LIBERTY PARK

RE: SUB 2002-41 -- Final Plat of Liberty Park Addition

RE: SUB 2002-41 -- Final Plat of Liberty Park Addition

CASE NUMBER: SUB 2002-41 -- LIBERTY PARK ADDITION

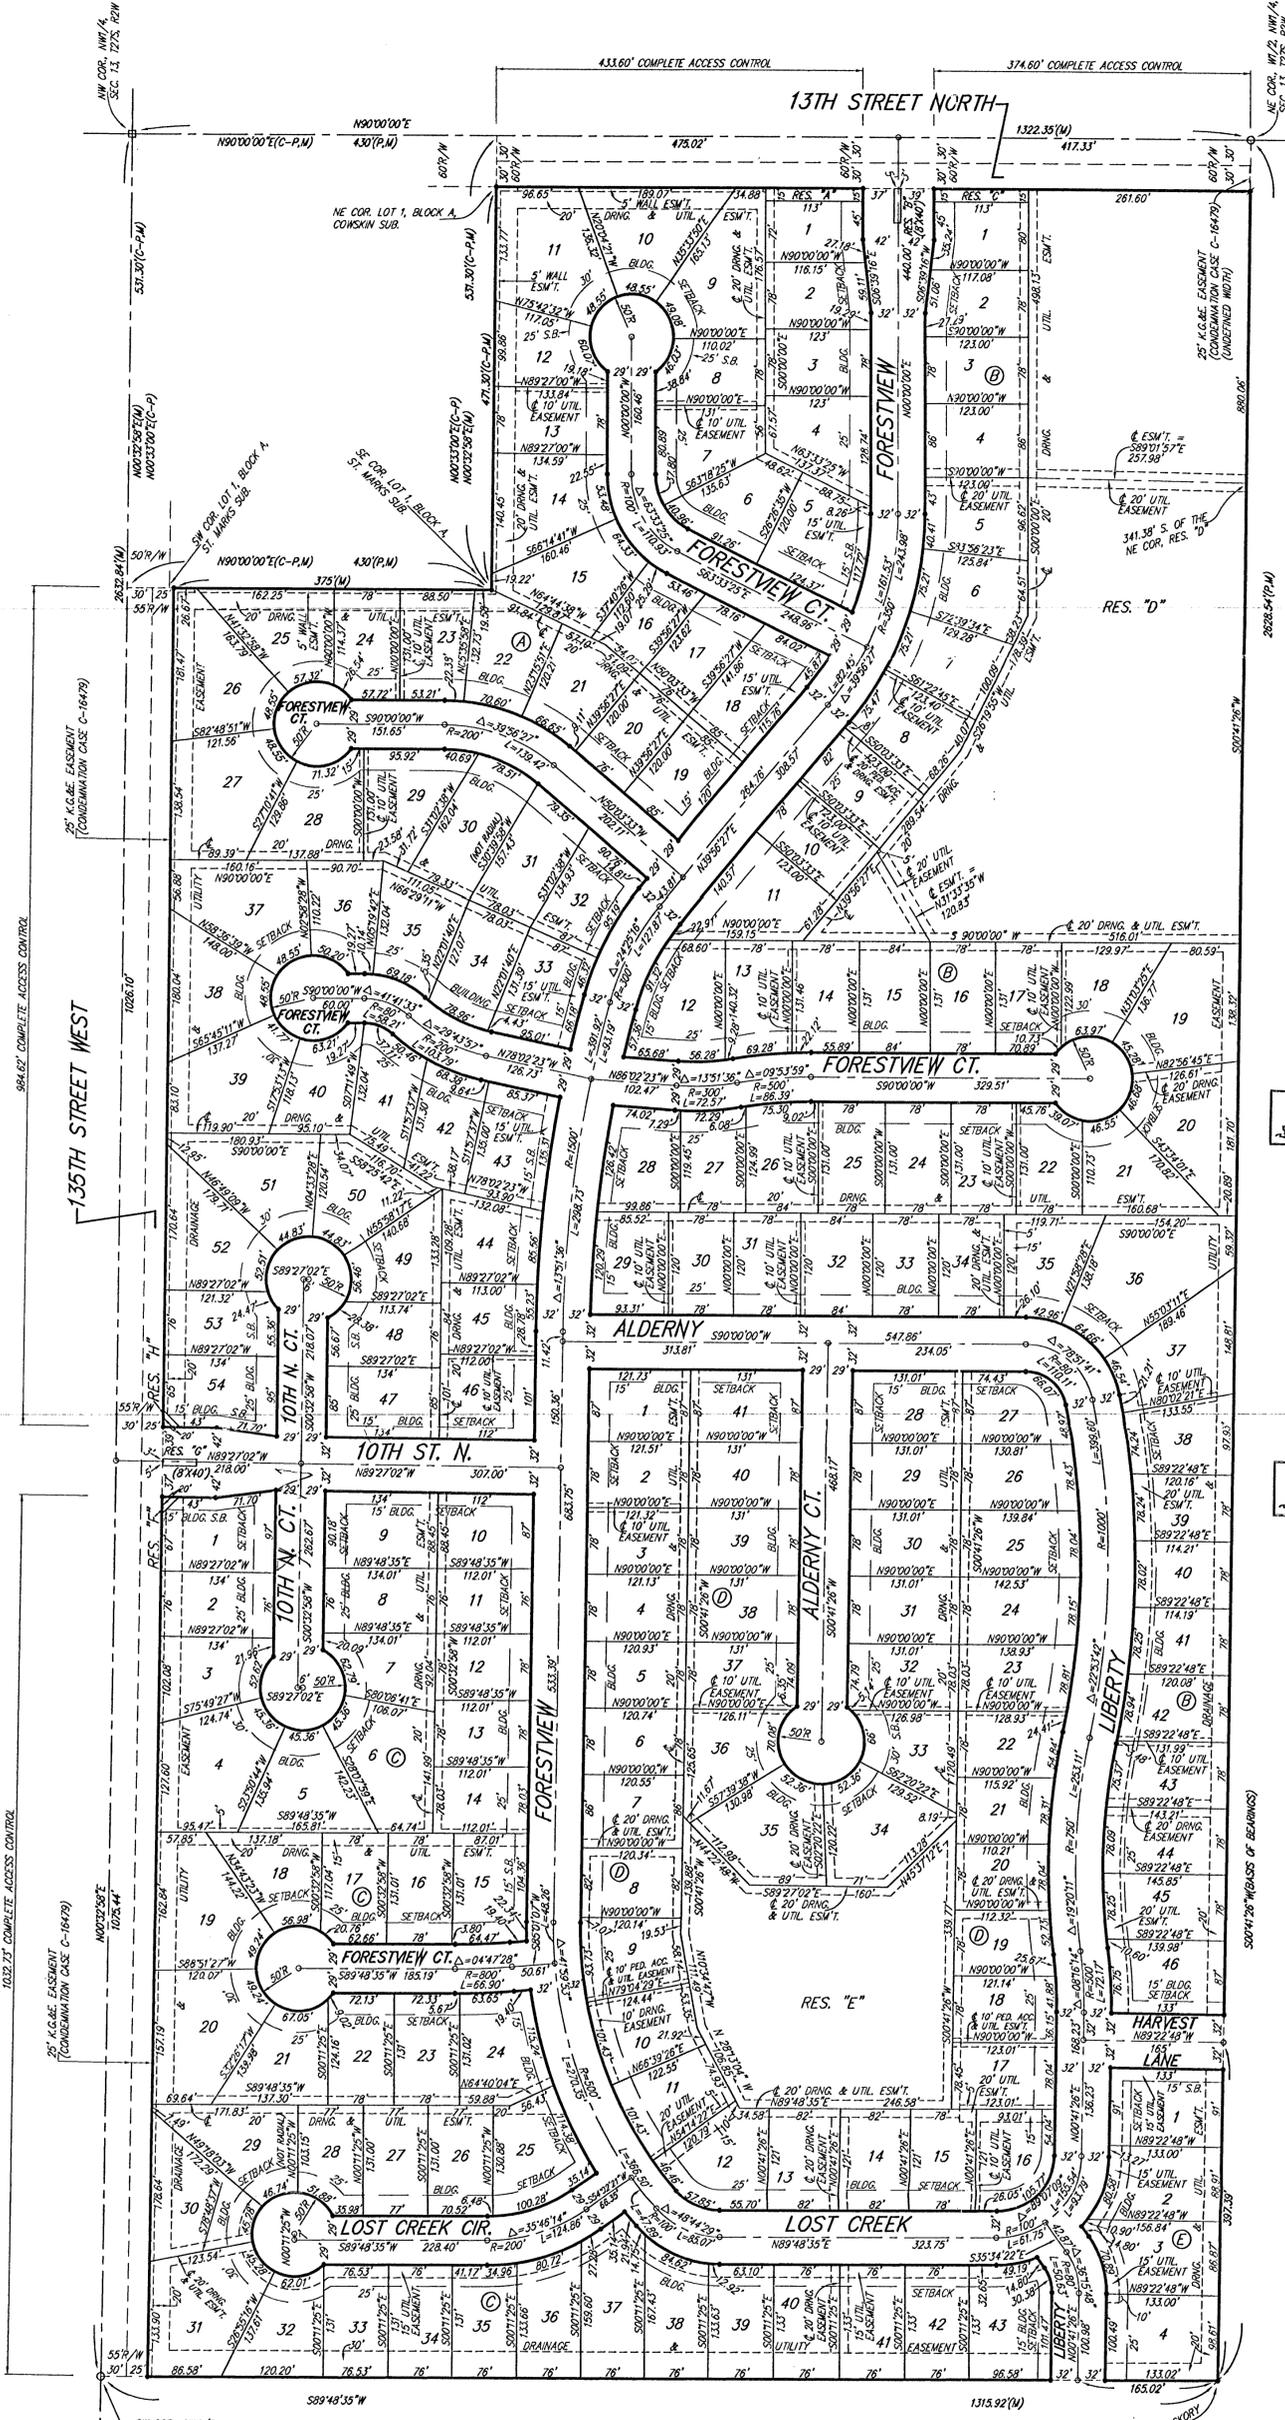
- A. Prior to this plat being scheduled for City Council review, annexation of the property will need to be completed. Upon annexation, the property will be zoned SF-5, Single-Family Residential and allow for the lot sizes being platted.

- B. The applicant shall guarantee the extension of sanitary sewer and City water to serve the lots being platted.
- C. If improvements are guaranteed by petition, a notarized certificate listing the petitions shall be submitted to the Planning Department for recording.

- D. City/County Engineering needs to comment on the status of the applicant's drainage plan. City Engineering has approved the drainage plan. A guarantee is required.

- E. The applicant shall guarantee paving of 13th Street North from Hickory Creek to Forestview including a left turn bay at Forestview. The applicant shall also guarantee construction of a left turn bay on 135th Street at Alderny Ct.

- F. A street stub should be shown to the south for increased mobility when development occurs in this location.

- G. The Applicant shall guarantee the paving of the proposed streets. The guarantee shall also provide for sidewalks on at least one side of all through, non cul-de-sac streets.
- H. It is recommended that Reserves D and E be extended to the streets by access easements or by extensions of the Reserves between the lots to increase their accessibility and usefulness for all homeowners in the Addition

- I. Provisions shall be made for ownership and maintenance of the proposed reserves. The applicant shall either form a lot owners' association prior to recording the plat or shall submit a covenant stating when the association will be formed, when the reserves will be deeded to the association and who is to own and maintain the reserves prior to the association taking over those responsibilities. This covenant shall also provide for the Homeowners' Association to maintain the "parking strip" located between this site's north property line and driving surface for 13th St. North.

- J. For those reserves being platted for drainage purposes, the required covenant which provides for ownership and maintenance of the reserves shall grant, to the City, the authority to maintain the drainage reserves in the event the owner(s) fail to do so. The covenant shall provide for the cost of such maintenance to be charged back to the owner(s) by the governing body.

- K. The applicant shall submit a covenant which provides for four (4) off-street parking spaces per dwelling unit on each lot which abuts a 58-foot street. The covenant shall inventory the affected lots by lot and block number and shall state that the covenant runs with the land and is binding on future owners and assigns.

- L. The wall easement shall be referenced in the plattor's text.
- M. The City Fire Department/GIS needs to comment on the plat's street names. 10th N. Ct. should be revised to 10th Ct. N.

- N. For any lots with existing tree rows that may be impacted by the installation of utilities, it is recommended that 30-ft utility easements be platted in order to allow for the installation of the utilities without damage to such tree rows. The applicant has agreed to plat an appropriate easement to avoid damage to the tree row.

- O. The plattor's text shall include language that a drainage plan has been developed for the plat and that all drainage easements, rights-of-way, or reserves shall remain at established grades or as modified with the approval of the applicable City or County Engineer, and unobstructed to allow for the conveyance of stormwater.

The applicant has extended Liberty to the south line of the plat as requested.

Pedestrian easements have been platted as requested.
